**TO:** Mayor Andre Dickens, City of Atlanta  
**ATTN TO:** Monique Forte, Planner III, City of Atlanta  
**FROM:** Mike Alexander, Director, ARC Center for Livable Communities  
**RE:** Development of Regional Impact (DRI) Review

**Name of Proposal:** 1359 Ellsworth DRI 3613

**DRI Number** #3613  
**DRI Title** 1359 Ellsworth  
**County** Fulton County  
**City (if applicable)** City of Atlanta  
**Address / Location** East side of Ellsworth Industrial Blvd

DRI-1

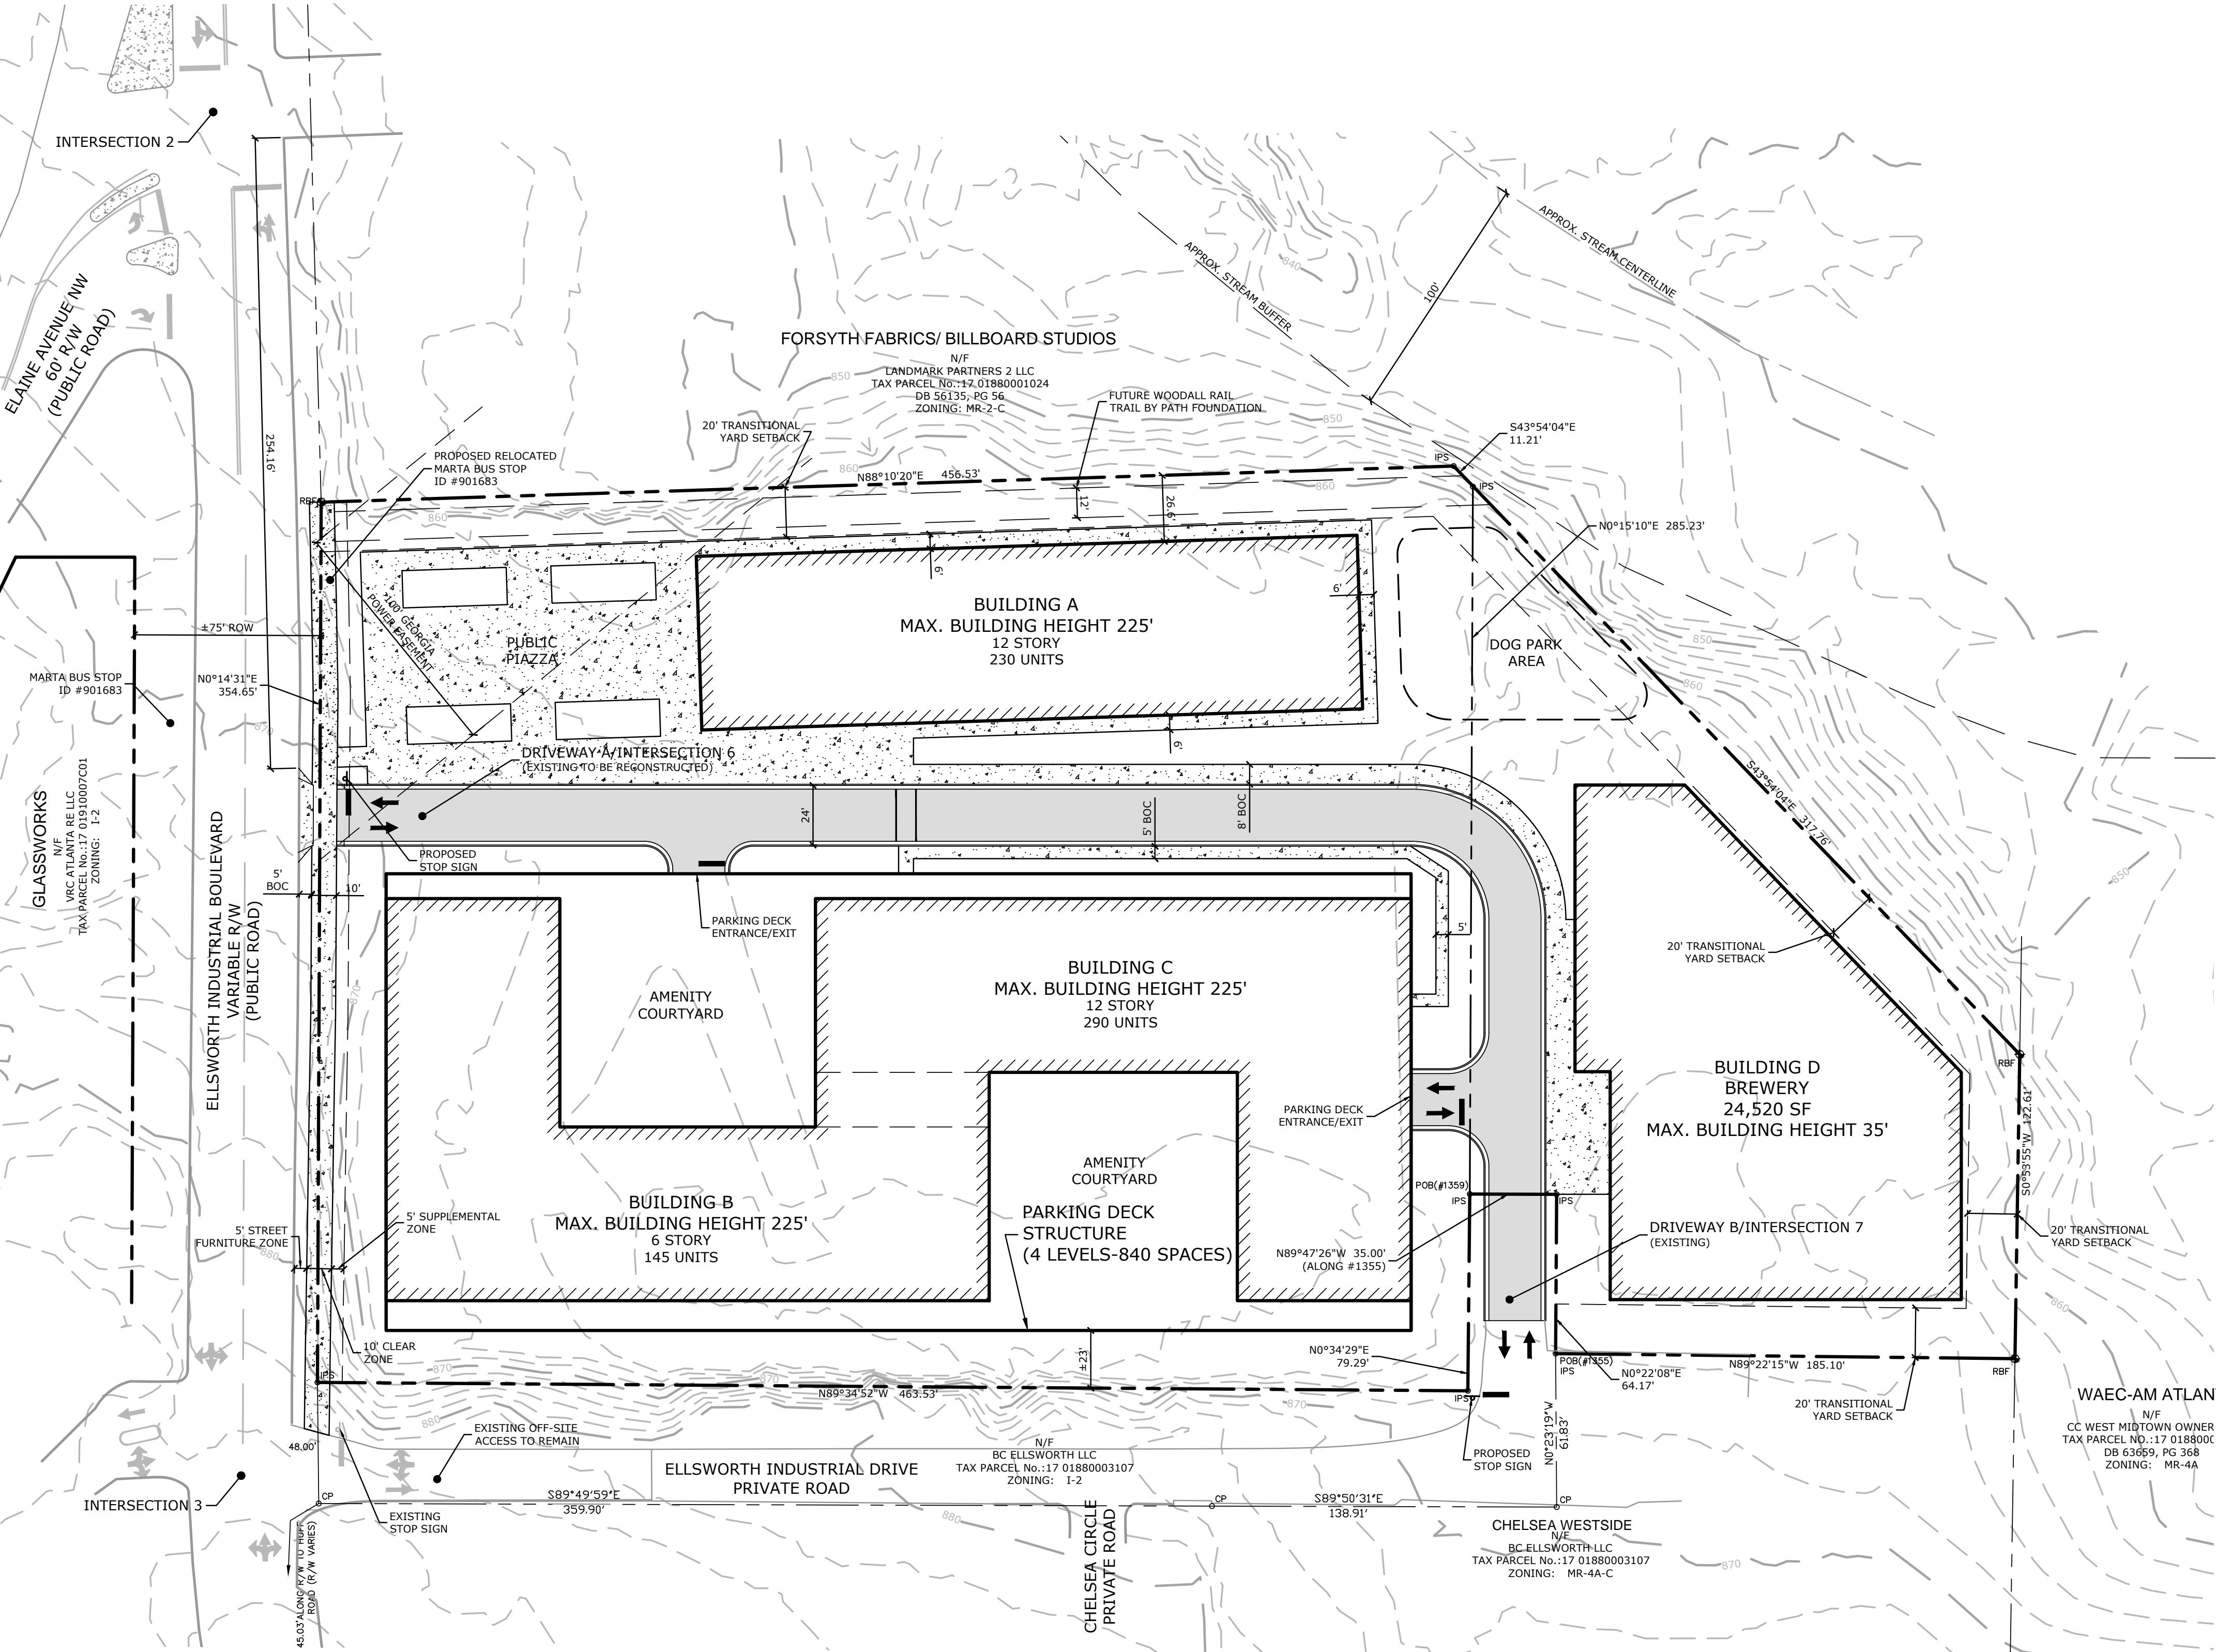
The current site plan proposes a 12-foot width for the Woodall Creek PATH trail. Confirmation that the Beltline will be constructed in this location will likely require allocation of a wider space to accommodate the Beltline width.

MARTA provided several comments on the project. The number of the bus stop adjacent to the project is incorrect on the plan; the correct number is 902230. MARTA is supportive of relocating this stop in the general vicinity to accommodate the project as long as the new stop has a 5 ft 8 in clear zone landing pad, is fully ADA accessible, will include a shelter, and is connected to the adjacent sidewalk.

The project is bounded on the south by a private drive and there is no crosswalk across the drive for the sidewalk on the east side of Ellsworth Industrial Boulevard. A safe crosswalk in this location will be required to accommodate pedestrian access from the south of the project.

The USGS coverage for the project area as well as the project site plan show an unnamed blue-line stream to the east and northeast of the northeast corner of the project property. The site plan shows a 100-foot buffer from the approximate center line of the stream, which does not reach the project property. However, the City of Atlanta stream buffers are 75 feet in width and measured from the point of wrested vegetation. If any portion of the project property is within the City stream buffers as defined under the City stream buffer ordinance, it will be subject to the requirements of the City ordinance, and the buffer should be shown on the project site plan. If any portion of the project property is within 25 feet of the wrested vegetation on the stream, it will be subject to the State 25-foot State Sediment and Erosion Control buffer. Any unmapped streams on the property may also be subject to the City buffer ordinance and any unmapped State waters identified on the property may also be subject to the State 25-foot Sediment and Erosion Control buffer.

The exact city and state stream buffer locations for Woodall Creek are not clear on the plans. DCA Form 1 notes that "Woodall Creek is adjacent/to the east. The CoA/State undisturbed buffers today encroach into the existing developed site. This project proposes to remove existing impervious area within the buffers and improve conditions of permanent ground cover on existing site to prevent/reduce existing erosion into

Sidewalks are proposed for the development's frontage. It appears the site plan references internal sidewalks, but the pedestrian crossings are not easily identified on the site plan to access Buildings A and D from the parking deck located at Building C. It is advised to clearly identify pedestrian features on the site plan. Plus, there are no visual pedestrian crosswalks to access the southbound MARTA stop or the proposed bus stop relocation.
